Partial Urban Design Assessment

to support s.95 assessment

Date: 19 December 2024 – Final
From: Ekin Sakin, Principal advisor urban design
To: Scott Blair, Senior Planner

RMA/2024/2460 390-408 Prestons Road

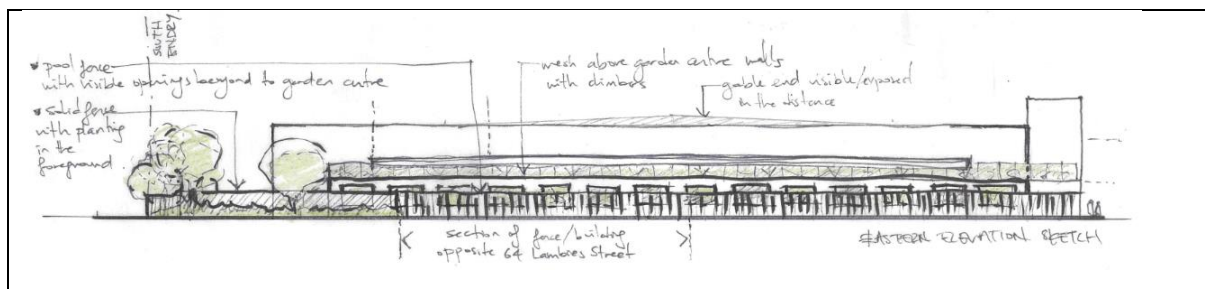
The lowest component of the Mitre10, the garden centre building, is located at the Marshland Domain interface and is approximately 69m long along this boundary. I consider it to be a low rise, moderate scale building, similar to the five buildings located along Prestons Road.

The garden centre is a low building with a perimeter wall height of 3.5m with an additional 1.5m of see-through mesh fence above. The light roof structure and the walls are separated, hence it is open to air. The height of the roof is approximately 5m.

The next height that would be observed from the east is the parapet of the retail function of the Mitre10 building, approximately 38m away from the eastern boundary. The height of this parapet is 8.5m, increasing to 11m at about 67m away from the eastern boundary.

The roof ridge beyond the parapet is approximately 10m high, centrally located (30m away from the north and south edges) on the retail building. A very shallow triangle (the peak of the gable end) above the 8.5m parapet could be visible from the east. I calculate this triangular area to be about 30m² across 41m and believe that it would be almost imperceptible for the human eye level on the ground from most angles due to its large distance from the building's edges.

I expect the visual effect of the location of the lower garden centre to the east and the stepping of the parapet to be one of gradual increasing of heights which is an acceptable method to moderate the impact of larger scale buildings.

Above: Building/parapet setbacks from the south boundary
 Below: Planting plan at the south boundary

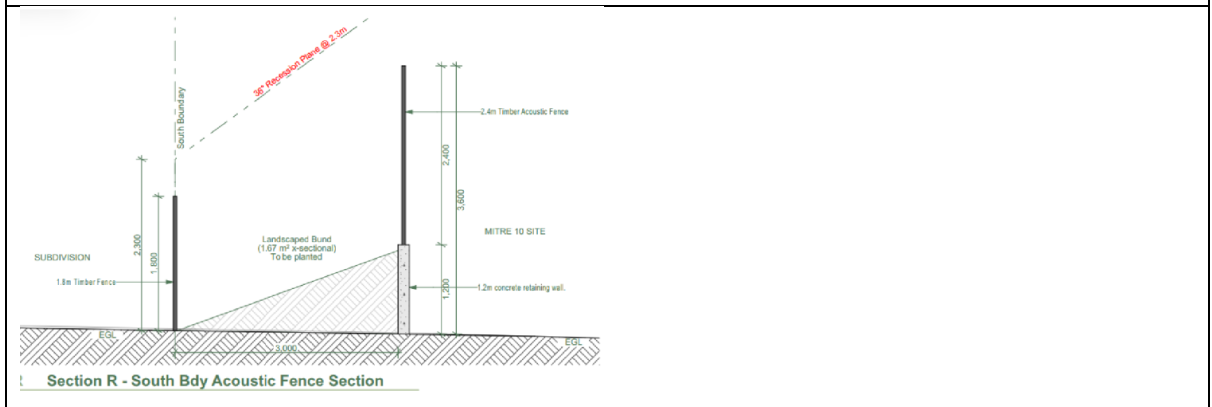
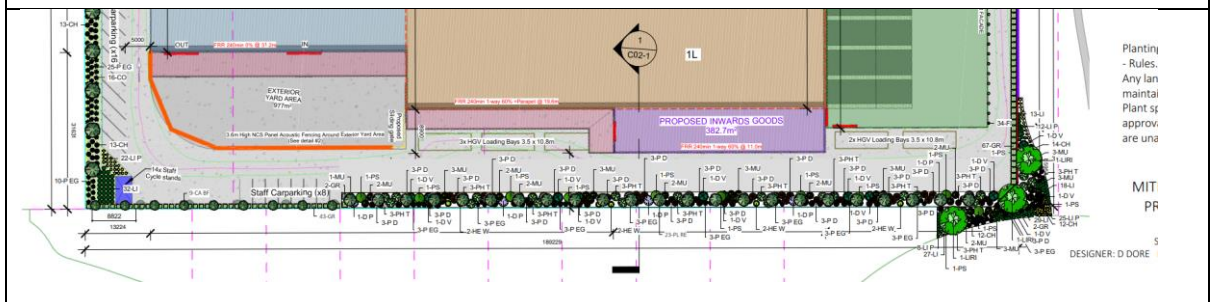
The proposed methods for moderation of the scale and integration at the southern boundary are:

- 3m wide densely planted buffer including an acoustic fence on the Mitre10 side. See Section R below.
- Building set-backs from the residential boundary at approximately (dimensions from the drawings rounded to the nearest metre) 30m for the western most four residential parcels, 20m for the three middle parcels, 11m for two eastern parcels and 16m for the easternmost parcel.

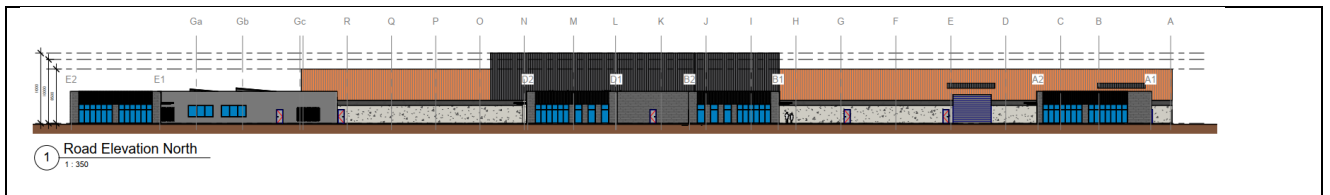
Building E Building E is located on the northern half of the Domain boundary. It is greater than 50m length along this boundary and is designed in seven bays. Three out of these seven bays are provided with glazing. These bays if left without canopies, would detract from attractiveness of the Domain as the building would be turning its back to the domain. Providing canopies associated with the glazing as it is proposed for the other buildings on the site, would help reduce this effect to a just acceptable level.

Mitre10 Garden centre and beyond Between the main Mitre10 building and the Marshland Domain, to the east there is an approximately 30m deep garden centre which is a lighter structure with mostly open to air edges and roofing. This side of the building does not contain the signature orange colour which reduces risk of unattractiveness. While a high level of vibrancy is not provided to this edge, the pedestrian access would be an improvement on the level of vibrancy to the existing state which comprises a continuous solid fence.

To the east, the main Mitre10 building in the background includes the very large size of the word “mega” which would undermine the attractiveness of Marshland Domain, particularly in long views. The smaller commercial complex on the other side of Marshland Domain is visible from the tennis court edge which means the higher part of the Mitre 10 building and the very large text would also be visible in long views from near Prestons Park drive.

The conclusion of whether the Marshland Domain edge attractiveness is not undermined, is critically reliant on a minimum of one in every two to three open bays of the garden centre remaining see-through with plants visible (as distinct from other stock or blocking of views by other means) and the word ‘mega’ being removed or significantly reduced in size.

North elevation from Prestons Road- the Mitre10 building is approximately 90m away from the road (elevation collage by author)

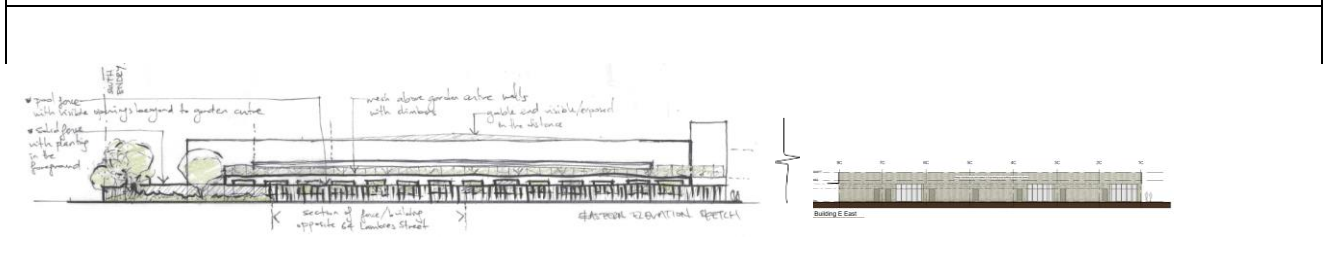
From the north, in addition to the smaller buildings being located between the road and the Mitre10 building, further moderation of the perceived scale of the Mitre 10 building is achieved through the differentiation of the Mitre10 parapet heights along the north elevation. I consider that this graduation combined with the 90m distance between the north elevation and Prestons Road, mitigates the perceived bulk to a just acceptable level for these views.

The graduation of heights from east to west (left to right on the image) away from Marshland Domain is also demonstrated on this elevation.

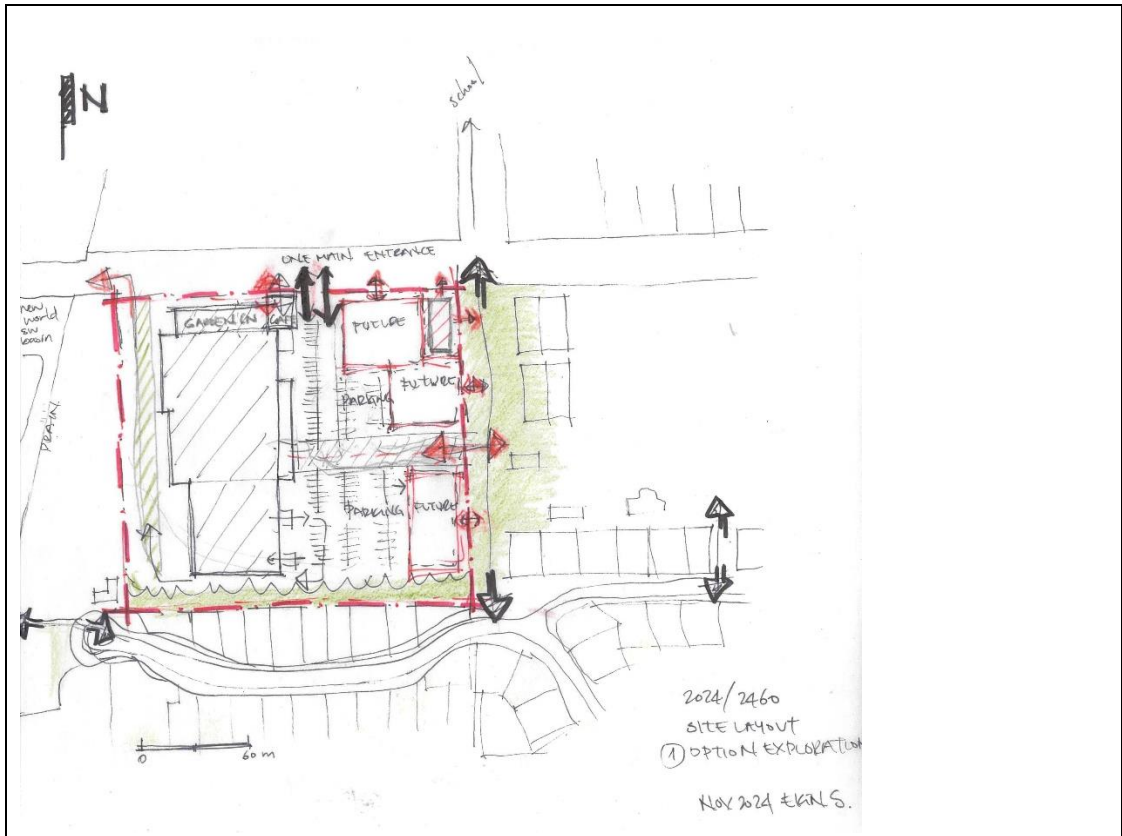
However, the large car parking areas and the pedestrian routes do not have sufficient shade or weather protection. Commercial developments with associated large car parking areas typically achieve this by providing trees at every interval of five or so car parks, especially along pedestrian routes across the car park.

The main pedestrian axis on the car parking area that runs east west has planting areas adjacent however only some of these areas appear to include canopy trees and these are located to the south which may not be as effective for shading purposes.
